JOINT DEVELOPMENT CONTROL COMMITTEE - CAMBRIDGE FRINGES

4 14/1410/REM: Public Realm for Darwin Green Local Centre *(Pages 15 - 60)*

Pre submission briefing for the Darwin Green One Local Centre (Reserved Matters)

01 312 ILLUSTRATIVE SECTION 06 OPTION A: Indicating possible secondary retail spill-out area with tables & chairs

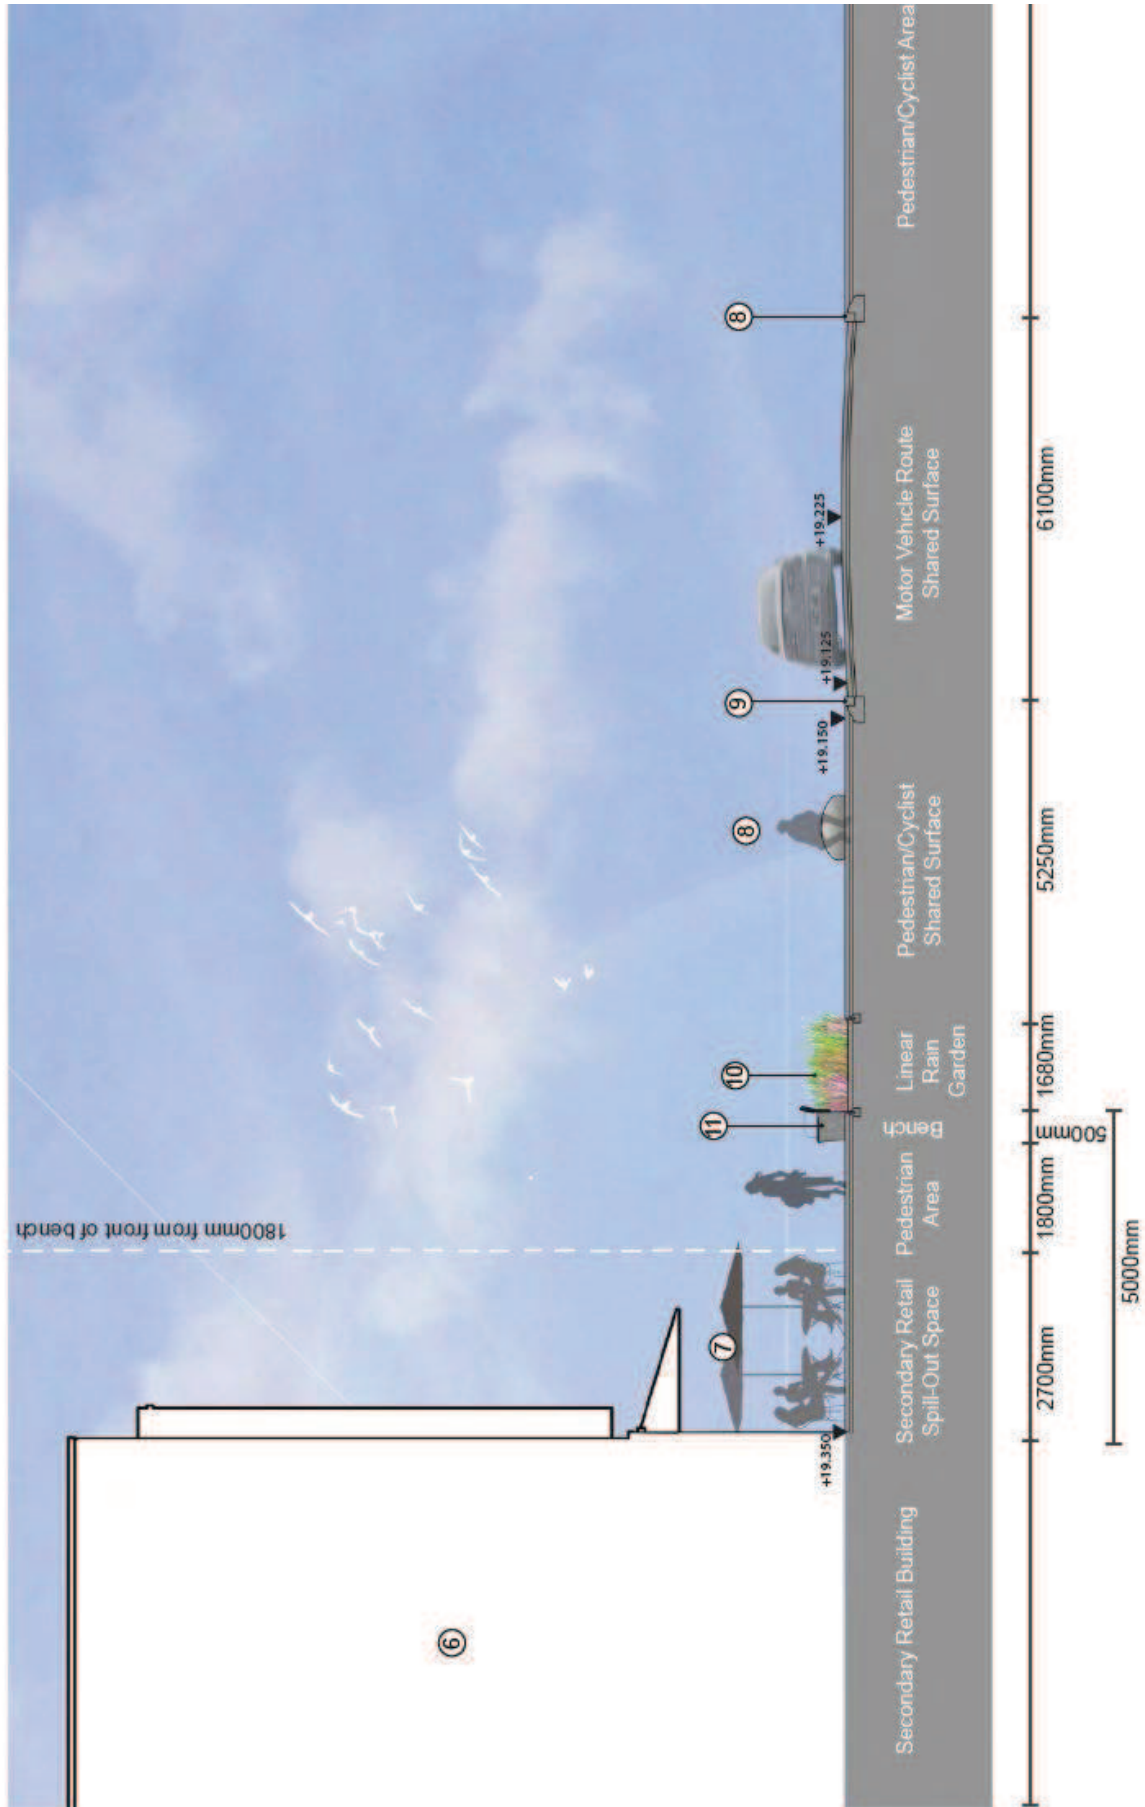
- 8.38 The retail units to the north east of the square will be serviced from the front using the delivery bay which is provided in the carriageway. This servicing arrangement was agreed in the Design Code and is intended to avoid conflict with other users (Design Code p 116). Given the size of the units there is unlikely to be a requirement for large HGV's. Servicing is expected to be made by light vehicles with a limited a frequency. Officers are satisfied that the design of the design makes adequate provision for servicing, and is in accordance with Local Plan policy 8/2.
